SUBJECT: Reduce noise on VCF
DATE: 14/10/14
MODEL(S): Xone:23 Xone:23C s/n X23X-493687

Replace components to reduce noise on VCF.

AG9058 PCB XONE:23/23C MAIN

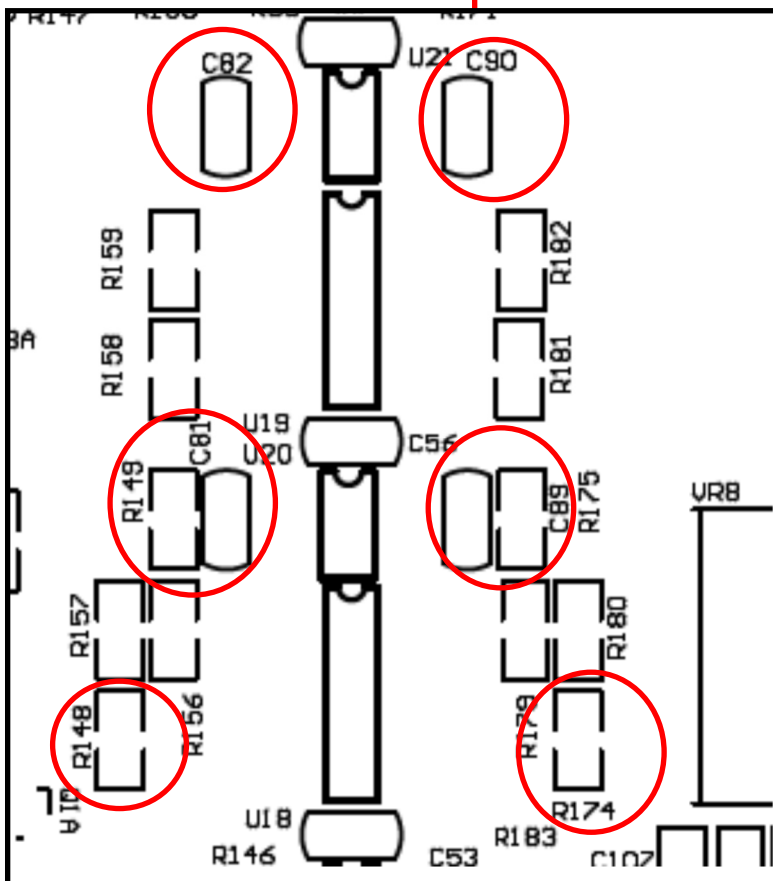
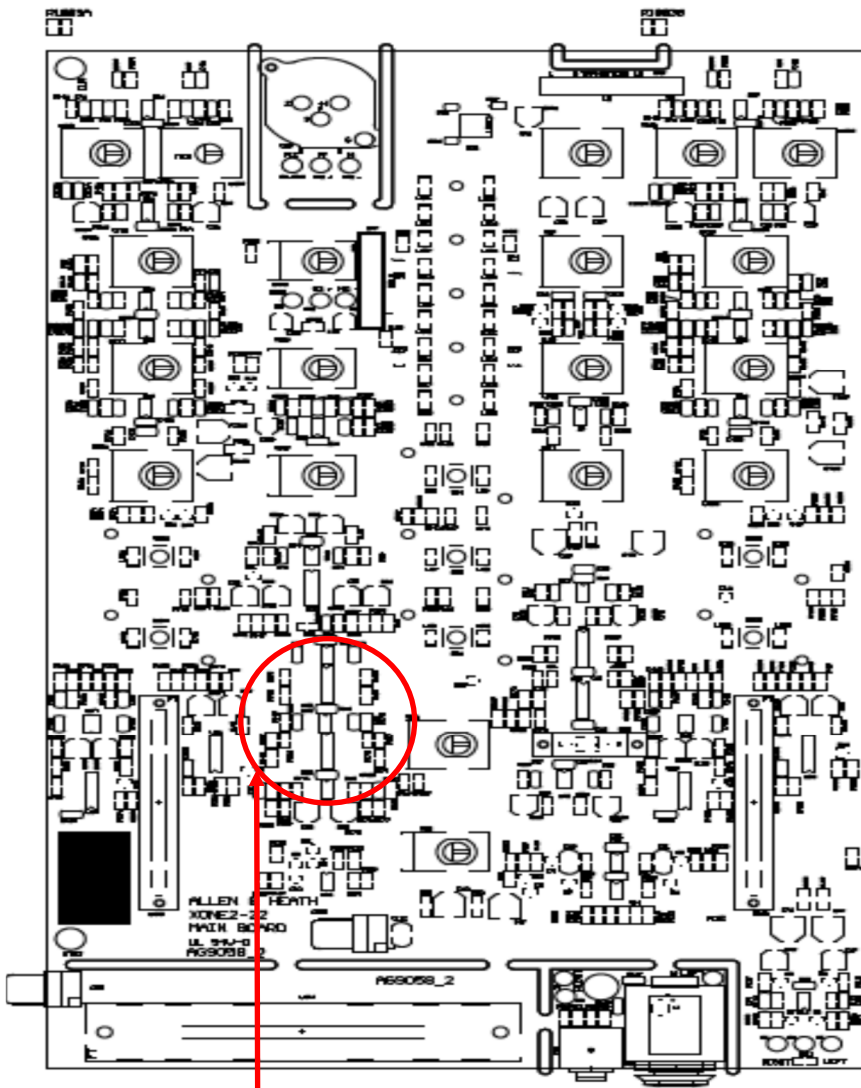
REPLACE
R148, R149, R174, R175

From
AC5341 RES SMD 30K 1% 0805

To
AC3062 RES SMD 4K7 1% 0805

REPLACE
C81, C82, C89, C90

From
AF3553 CAP SMD 680PF CER 0805

To
AF5415 CAP SMD 4.7NF CER, 0805 50V
10%

Change R148,R149,R174 & R175 from RESISTOR METAL SMD0805 30K 1% (AC5341) to RESISTOR METAL FILM SMD0805 4K7 1% (AC3062)

Change C81, C82, C89 & C90 from CAPACITOR CERAMIC SMD0805 680P (AF3553) to CAPACITOR CERAMIC SMD0805 4N7 (AF5415)
